Access Compliance Report

Public Rights-of-Way

Intersection ID: 50269	Main Street: SOUTH_BV	Cross Street: HARTFORD_AV	Location: NE
ADA ID: 4F9FB79A4480	Ramp Type: Perp	Initial Pass/Fail: Fail	Overall Compliance: No
Severity Score: 10			
Codes/Mitigation Info/Possible Solution		Field Measurements/Component Compliance

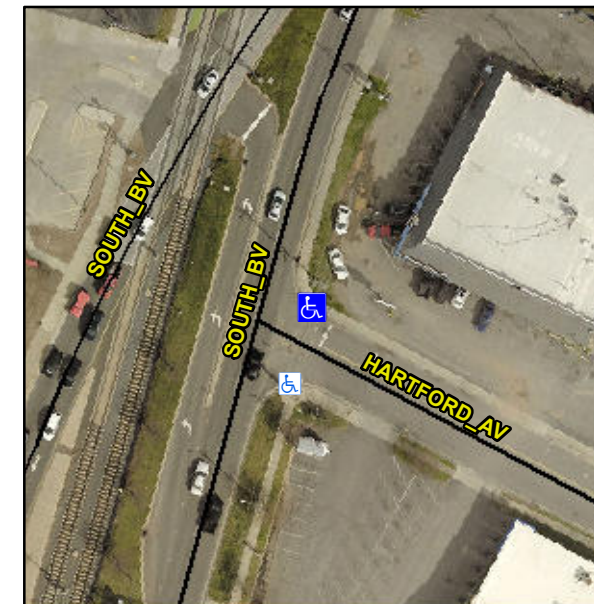
Not Found, R304.5.1, R304.5.3

Compliance	Description	Data	Compliance	Description	Data
N/A	Ramp Length (in)	72.0	Yes	Ramp Slope (%)	7.6
No	Ramp Width (in)	47.0	No	Ramp XSlope (%)	2.4
N/A	Flare Type LT	N/A	N/A	Flare Type RT	N/A
N/A	Flare Slope LT (%)	N/A	N/A	Flare Slope RT (%)	N/A
N/A	Flare Traversable LT?	N/A	N/A	Flare Traversable RT?	N/A
N/A	Landing Length (in)	N/A	N/A	DWS Provided?	N/A
N/A	Landing Width (in)	N/A	N/A	DWS Contrast?	N/A
N/A	Landing Slope (%)	N/A	N/A	DWS Length (in)	N/A
N/A	Landing X Slope (%)	N/A	N/A	DWS Full Width?	N/A
N/A	Landing Curb? (Y/N)	N/A	N/A	DWS Offset (in)	N/A
N/A	Shared Landing?	N/A			
N/A	Gutter Ponding?	N/A	N/A	Gutter Slope (%)	N/A
N/A	Gutter Lip Ht (in)	N/A	N/A	Gutter X Slope (%)	N/A
N/A	Painted X Walk1?	No	N/A	Painted X Walk2?	N/A
	X Walk 1 Direction	To SW		X Walk 2 Direction	N/A
N/A	X Walk 1 Width (in)	N/A	N/A	X Walk 2 Width (in)	N/A
	X Walk 1 Slope (%)	0.4		X Walk 2 Slope (%)	N/A
	X Walk 1 X Slope (%)	0.7		X Walk 2 X Slope (%)	N/A

Remove & Replace Entire Ramp.
